Access Compliance Report

Public Rights-of-Way

(Curb Ramps)

Intersection ID: 9269	Main Street: BODKIN_CT	Cross Street: SPRINGHEAD_LN	Location: NW
ADA ID: 7B08CE942E25	Ramp Type: Perp	Initial Pass/Fail: Fail	Overall Compliance: No
Severity Score: 33.75			
Codes/Mitigation Info/Possible Solution		Field Measurements/Component Compliance

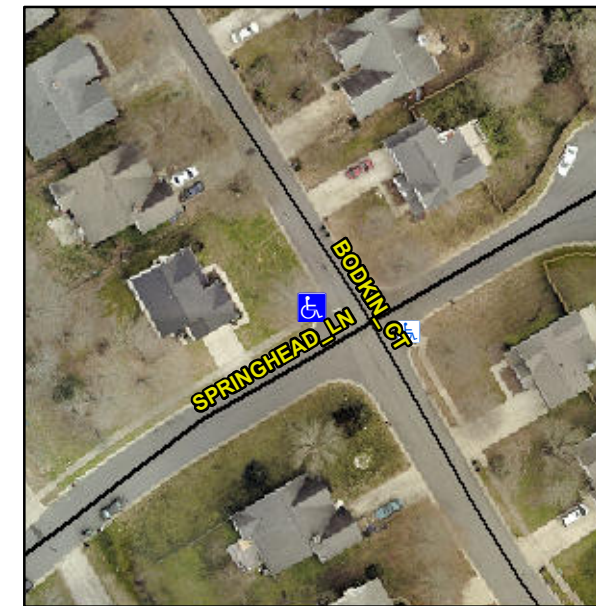
Not Found, R304.5.1, R304.5.3

Compliance	Description	Data	Compliance	Description	Data
N/A	Ramp Length (in)	53.0	Yes	Ramp Slope (%)	5.6
No	Ramp Width (in)	47.5	No	Ramp XSlope (%)	9.2
N/A	Flare Type LT	N/A	N/A	Flare Type RT	N/A
N/A	Flare Slope LT (%)	N/A	N/A	Flare Slope RT (%)	N/A
N/A	Flare Traversable LT?	N/A	N/A	Flare Traversable RT?	N/A
N/A	Landing Length (in)	N/A	N/A	DWS Provided?	N/A
N/A	Landing Width (in)	N/A	N/A	DWS Contrast?	N/A
N/A	Landing Slope (%)	N/A	N/A	DWS Length (in)	N/A
N/A	Landing X Slope (%)	N/A	N/A	DWS Full Width?	N/A
N/A	Landing Curb? (Y/N)	N/A	N/A	DWS Offset (in)	N/A
N/A	Shared Landing?	N/A			
N/A	Gutter Ponding?	N/A	N/A	Gutter Slope (%)	N/A
N/A	Gutter Lip Ht (in)	0.5	N/A	Gutter X Slope (%)	N/A
N/A	Painted X Walk1?	No	N/A	Painted X Walk2?	N/A
	X Walk 1 Direction	To NE		X Walk 2 Direction	N/A
N/A	X Walk 1 Width (in)	N/A	N/A	X Walk 2 Width (in)	N/A
	X Walk 1 Slope (%)	6.3		X Walk 2 Slope (%)	N/A
	X Walk 1 X Slope (%)	7.0		X Walk 2 X Slope (%)	N/A

Remove & Replace Entire Ramp.
